June 8, 2023

DOMINION ENERGY SOUTH CAROLINA (DESC)
VIRGIL C. SUMMER NUCLEAR STATION (VCSNS) UNIT 1
LICENSE AMENDMENT REQUEST – EMERGENCY RESPONSE ORGANIZATION
(ERO) AUGMENTATION TIME CHANGE, EMERGENCY OPERATIONS FACILITY
RELOCATION AND OTHER EMERGENCY PLAN CHANGES

1. Description and Assessment
2. Current VCSNS Emergency Plan Pages Mark-up
3. Revised (Clean) VCSNS Emergency Plan Pages
4. Table B-1 Comparative Chart
5. ERO Position Impact Summary
6. No Significant Hazards Consideration Justification
7. Offsite Response Organization Concurrence Letters
8. References

Figure 3.10.4 – 1 Proposed CERC Layout

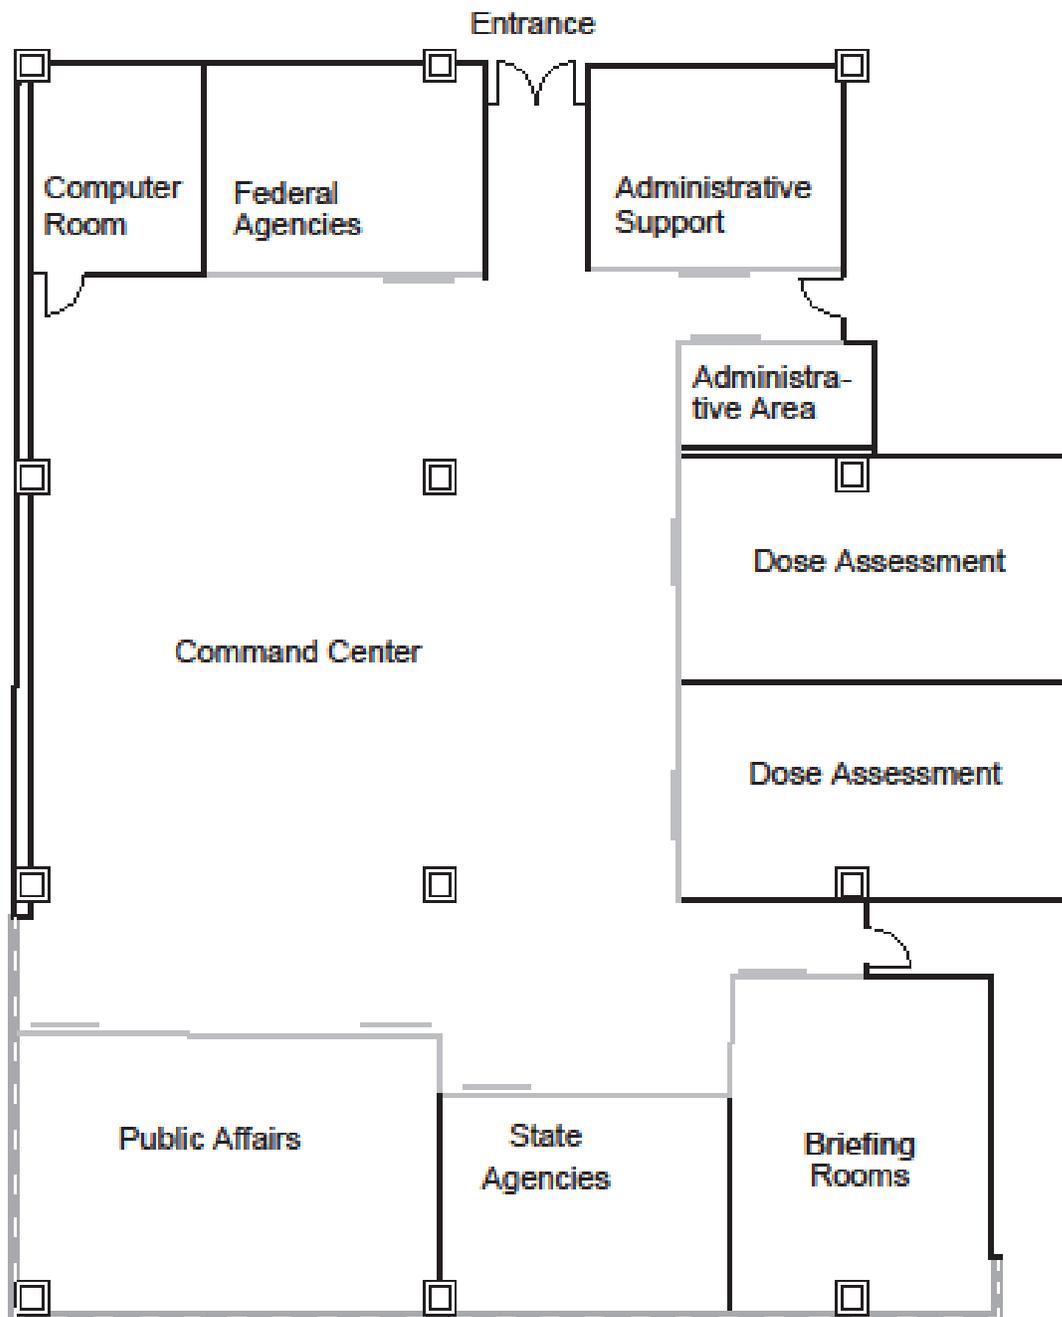
The total usable space of the CERC is approximately 5987 square feet. Based on the 75 square foot per person guidance of NUREG-0696, [8.9] this provides enough space for approximately 80 individuals. The expected number of EOF personnel during a dual-station event, including offsite agency responders, will be less than 60.

Space is allocated for accident assessment, radiation assessment and offsite monitoring, offsite communications, command and control, conferences, an NRC team, and administrative support. Space is sufficient for service of equipment and displays. Phones and special communications equipment are provided as needed throughout the facility at personnel workstations. Individuals needing access to plant data are provided access via personal computers (PCs). Space is provided for ready access to functional displays of data through the use of computer monitors and video display monitors.

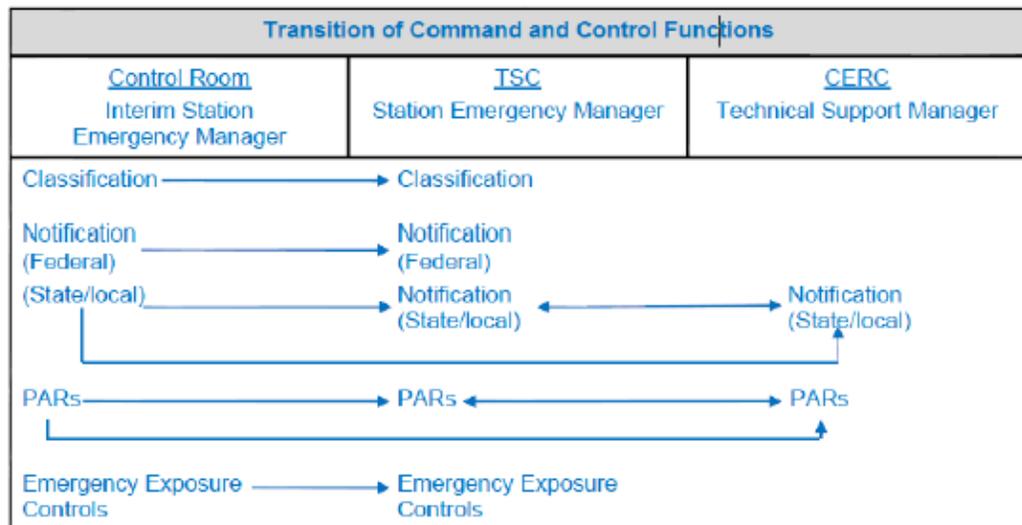
The Control Room is to be relieved of command and control as soon as possible after the declaration of an Alert or higher classification. ~~The overall~~ Command and control functions are transferred per the diagram below.

~~of the emergency is transferred directly to the ECO, as soon as possible. Command and control does not transfer to the TSC and EOF until the following criteria have been met:~~

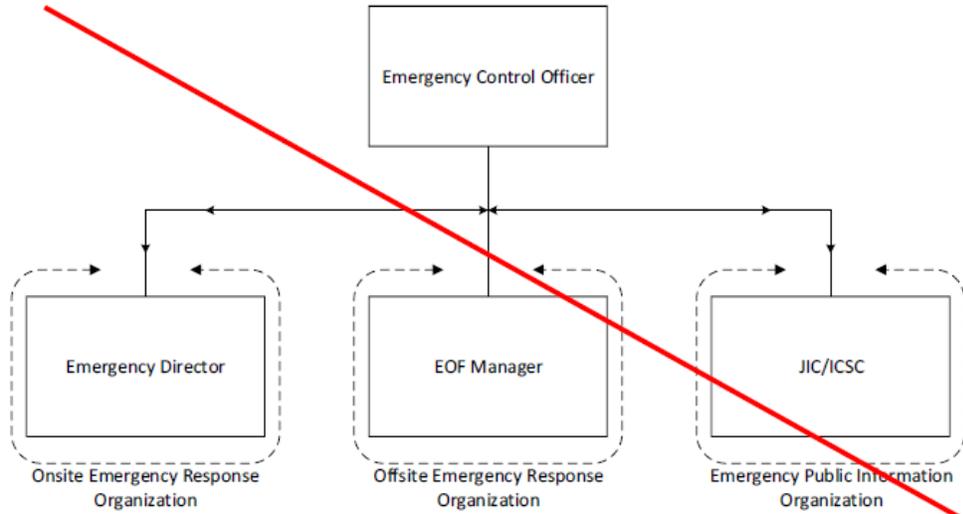
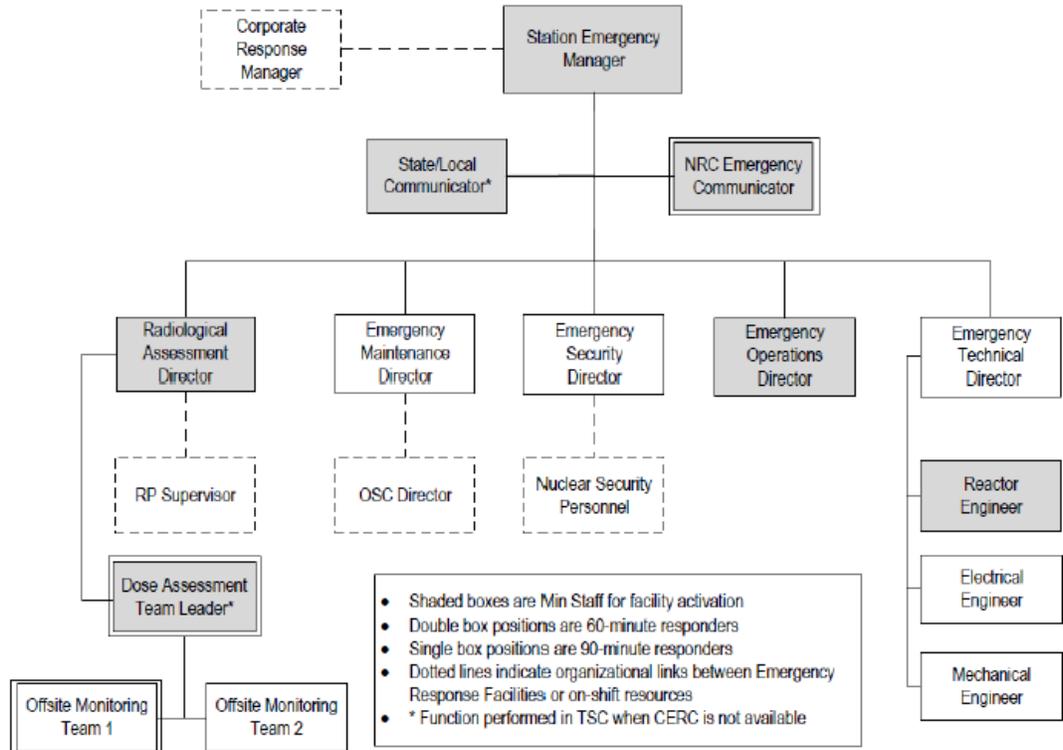
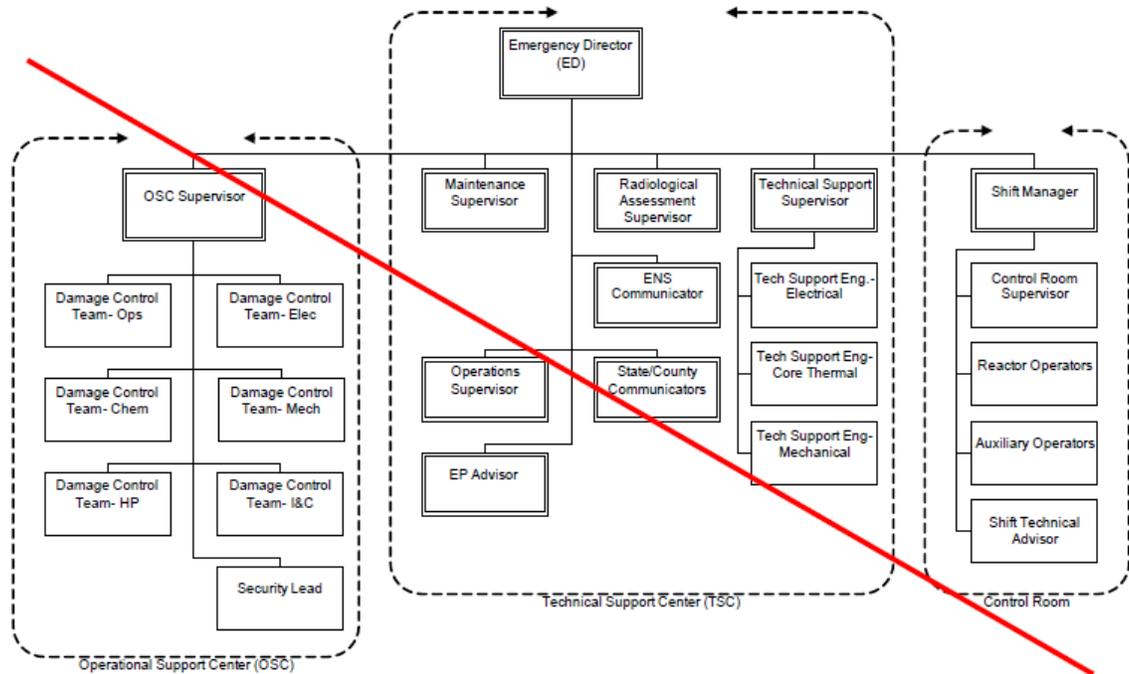
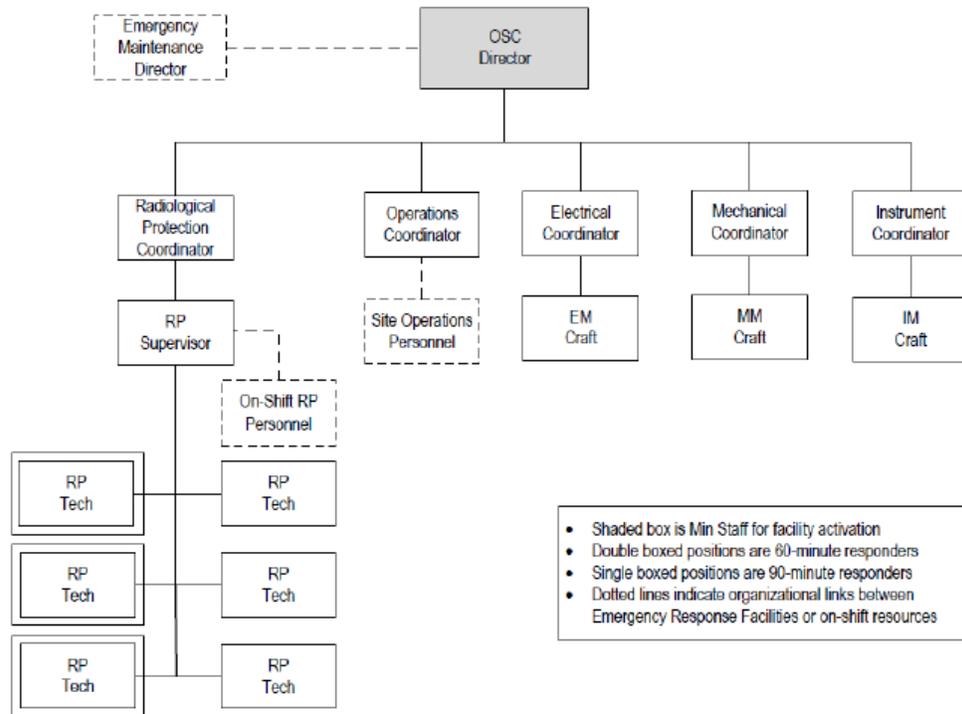
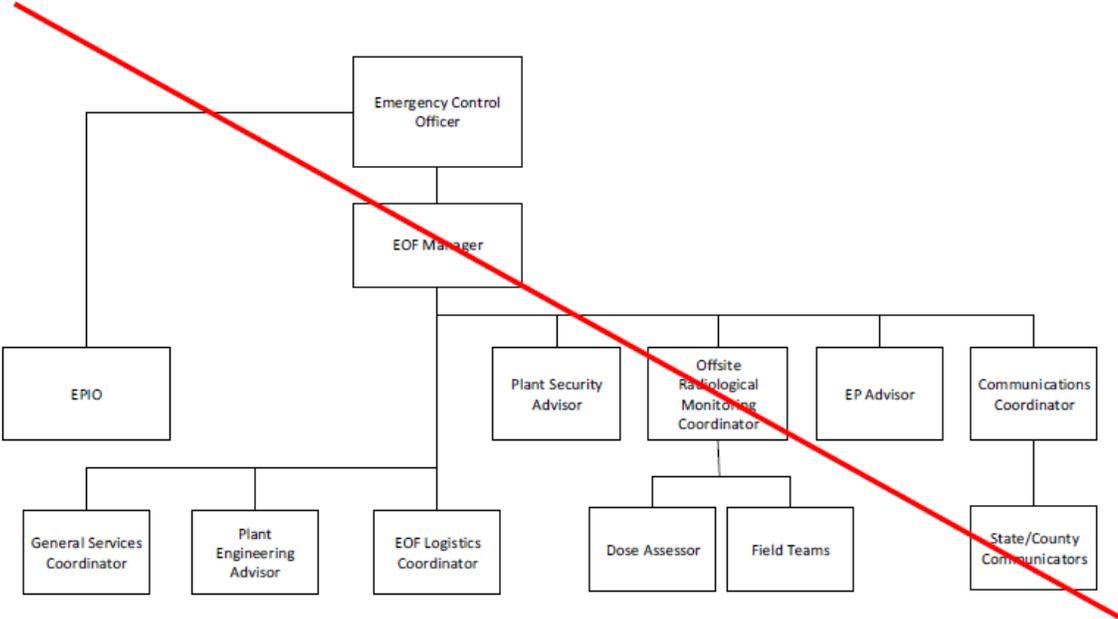
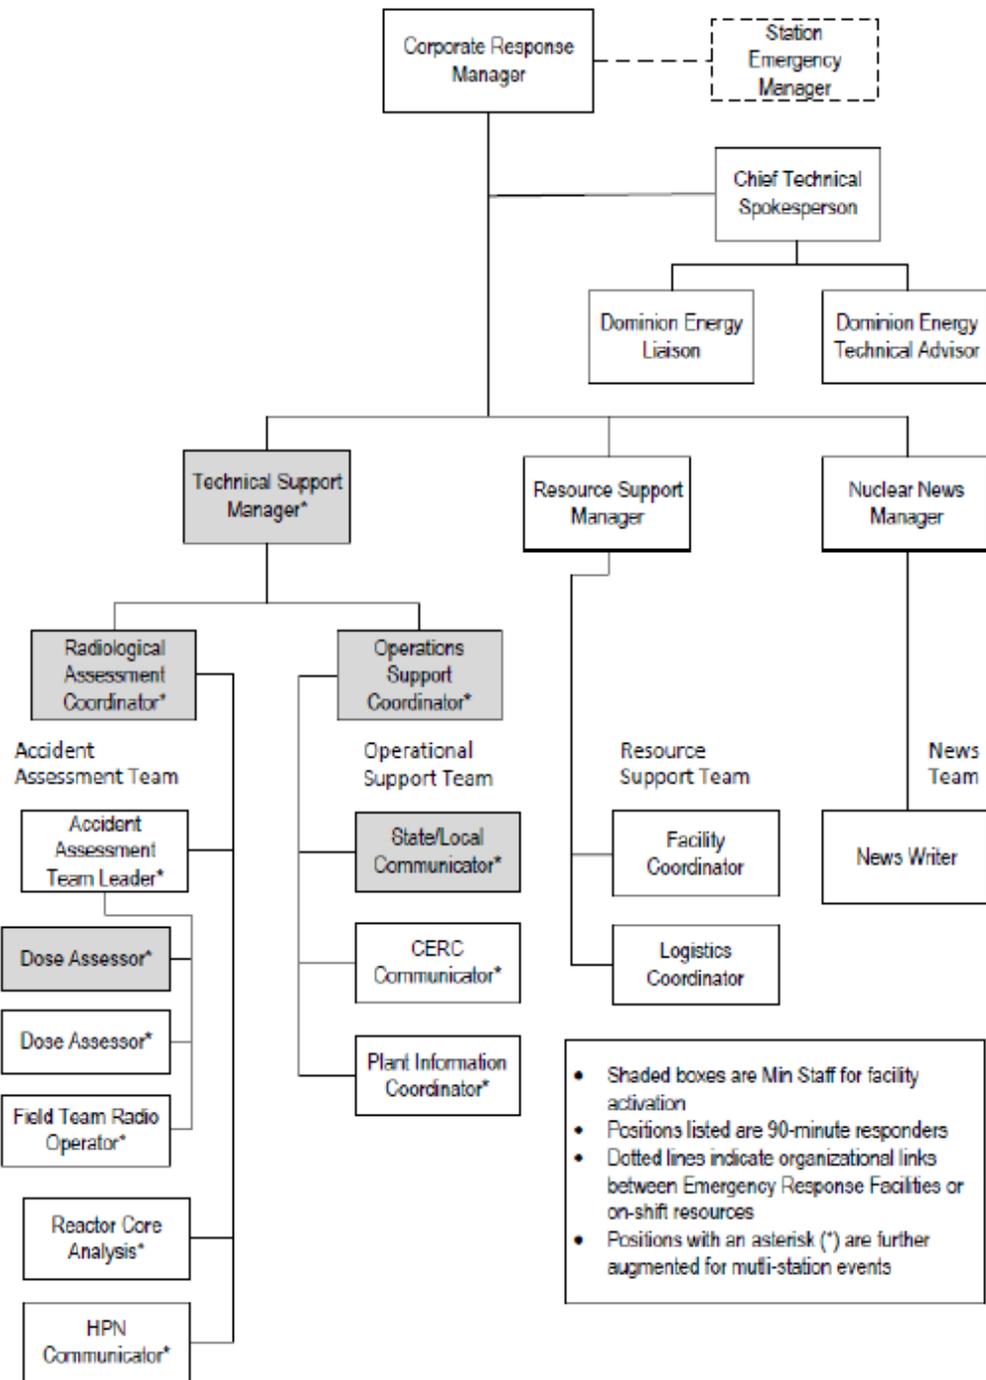
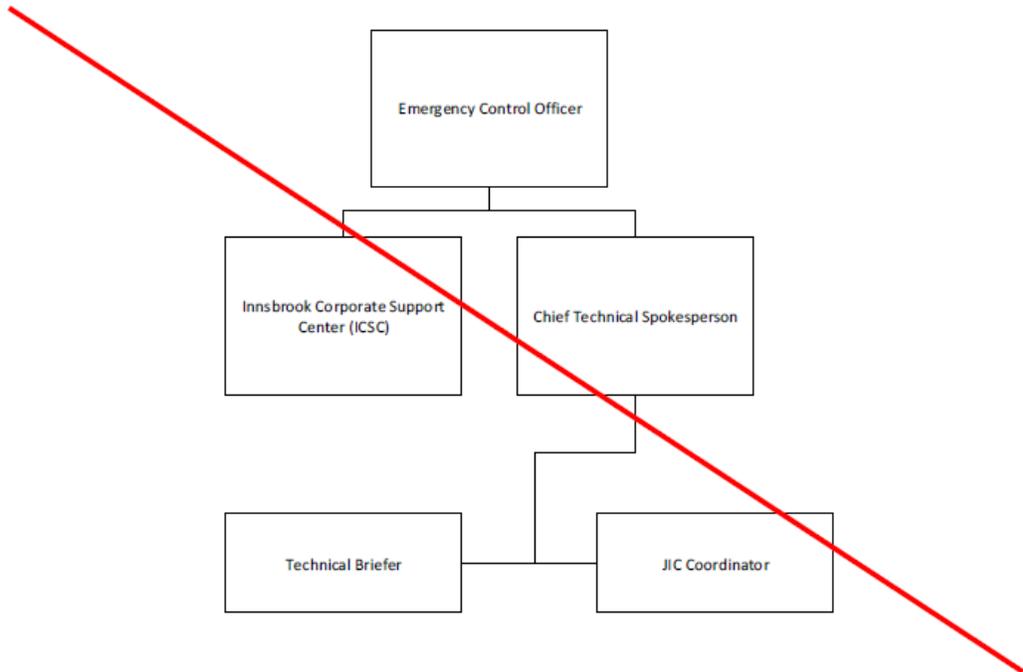
42	Part 2, Section B.5.c.2), 3) and 4)	Deleted 'Joint Information Coordinator', 'Technical Briefer' and 'Corporate Support Director (CSD)' positions to align with Dominion fleet standard ERO.
43	Part 2, Section B.6	Removed reference to 'Annex1 Table 2-1' and revised reference to "Section B-1" to read "Section B" as this section of the VCS Plan is being deleted under the proposed change.
44	Part 2, Figure B-1a	Overall ERO Command Structure is deleted and replaced with the TSC Organization in accordance with the proposed change.
45	Part 2, Figure B-1b	Onsite Emergency Response Organization is deleted and replaced by the new Figure B-1a, TSC Organization and new Figure B-1b, OSC Organization in accordance with the proposed change.

Table 1.2 - 1 Descriptions of Proposed Changes		
Change No.	Section	Description
46	Part 2, Figure B-1c	Offsite Emergency Response Organization, deleted and replaced with the CERC Organization in accordance with the proposed change.
47	Part 2, Figure B-1d	Emergency Public Information Organization is deleted. This organization is replaced by the CERC in accordance with the proposed change.
48	Part 2, Table B-1a	Staffing Requirements for the VCSNS ERO, deleted current table and replaced with revised table in accordance with the proposed change.
49	Part 2, Section C.1.c	Removed reference to facility accommodation detail to align with EP structure for other Dominion sites.
50	Part 2, Section C.2.a	Revised to identify the near site location available for use by offsite response personnel.
51	Part 2, Section D.1.a	Revised ERO position titles in accordance with the proposed change and revised NRC notification requirement to more closely align to 10 CFR 50.72.

Figure F-1: Notification Scheme (~~After Full Augmentation~~)

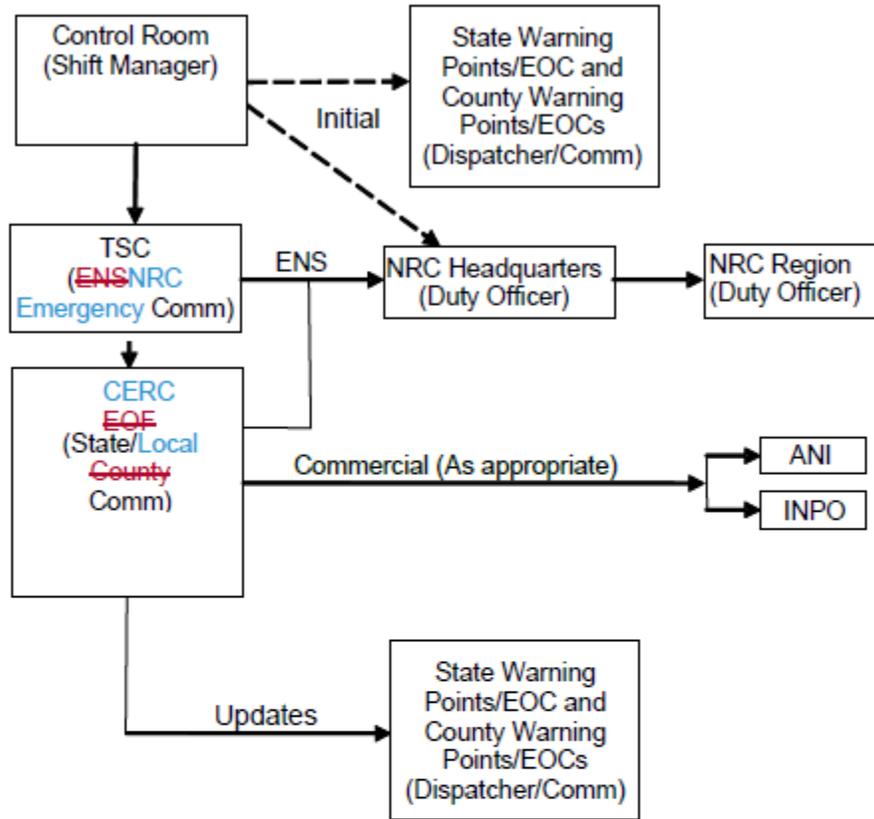
Figure F-1 depicts the initial notification paths and the organizational titles from the VCSNS Emergency Response Facilities (ERFs) to federal, state, and county EROs, and industry support agencies. The primary and alternate methods of communication, and the NRC communications network, are illustrated on Figures F-2 and F-3.

Figure F-3: NRC Communications for Nuclear Response

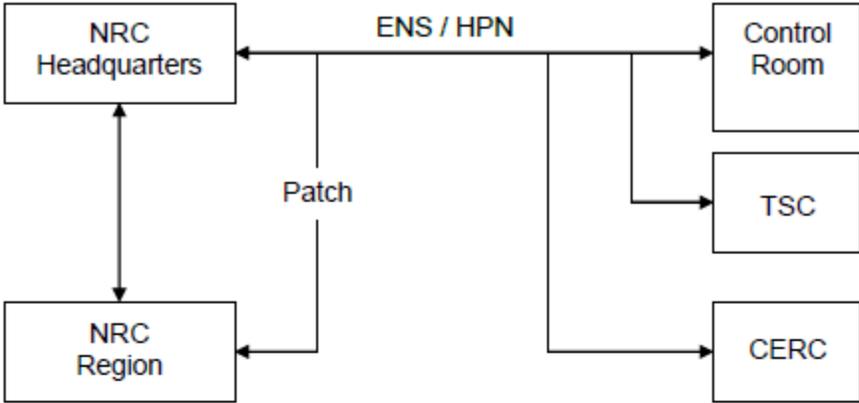
68	Part 2, Figure F-3	NRC Communications for Nuclear Response revised to replace 'EOF' with 'CERC' in accordance with the proposed change.
69	Part 2, Section G.1	Removed reference to 'EPIO' in accordance with the proposed change.
70	Part 2, Section G.3.a	Replaced reference to 'ICSC' with 'CERC' and added summary description related to news releases.
71	Part 2, Section G.3.a.1)	Deleted description of JICEPI Organization in accordance with the proposed change.
72	Part 2, Section G.3.a.2)	Deleted description of the JIC. New description included in Section H.2. in accordance with the proposed change.
73	Part 2, Section G.4.a	Deleted description of JIC staffing. Staffing described in Section H.2 and Section B, Figure B-1c.
74	Part 2, Section G.4.b	Replaced reference to Media and Rumor Control Monitor positions and added reference to Dominion Energy public information personnel as this group performs these functions under the proposed change.

Figure M-1: Example Recovery Organization

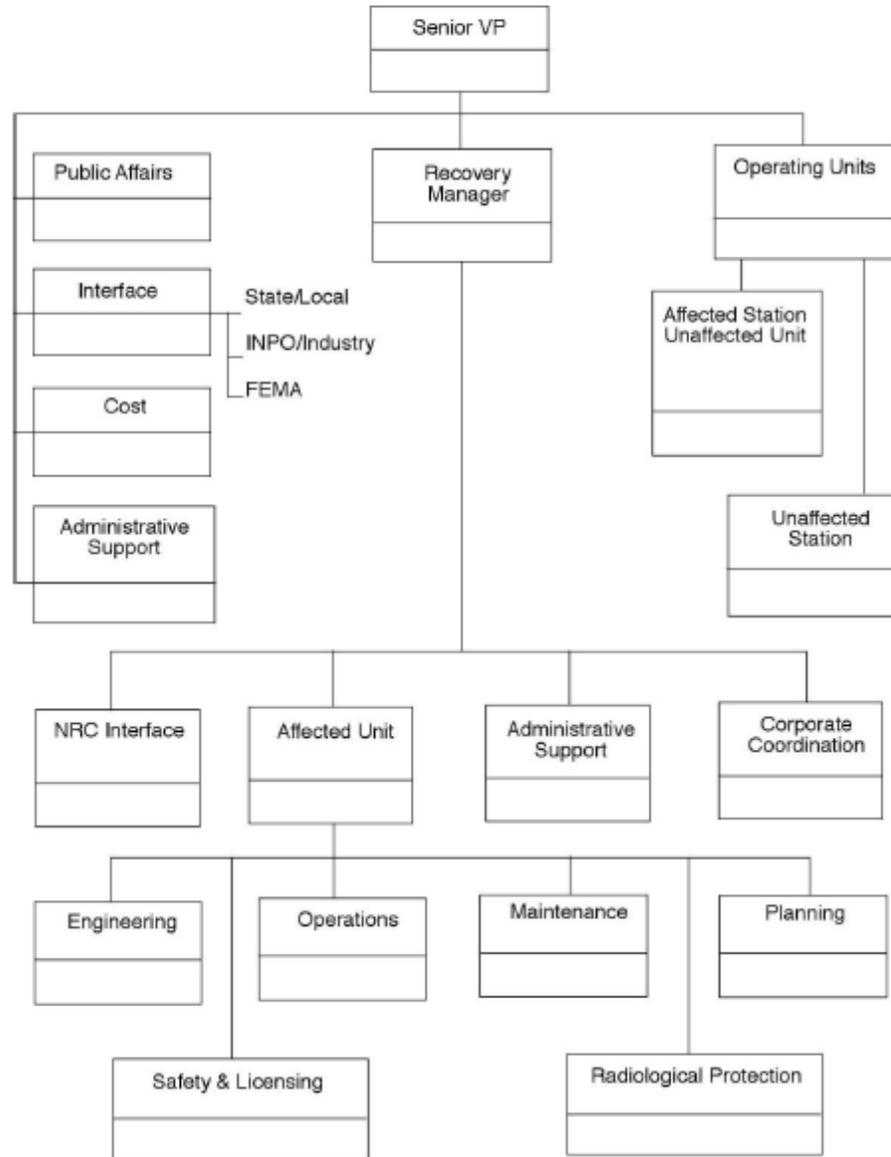
100	Part 2, Section M.2	Recovery Organization description to align with CERC processes, replaced department titles and removed positions descriptions now discussed in Figure M-1.
101	Part 2, Figure M-1	Inserted organizational figure for example Recovery Organization to align with the Dominion standard for event response.
102	Part 2, Section N.2.b	Removed reference to communication between the EOF and JIC as both of these functions are maintained as part of the CERC in accordance with the proposed change.
103	Part 2, Section N.2.c	Removed reference to fire drills as these are managed outside of the VCSNS Emergency Plan.
104	Part 2, Section N.2.f	Renumbered and removed reference to the EOF and the JIC as these are incorporated into the CERC in accordance with the proposed change.
105	Part 2, Section O.3	Removed section related to First Aid Response as this function is managed outside the VCSNS Emergency Plan.
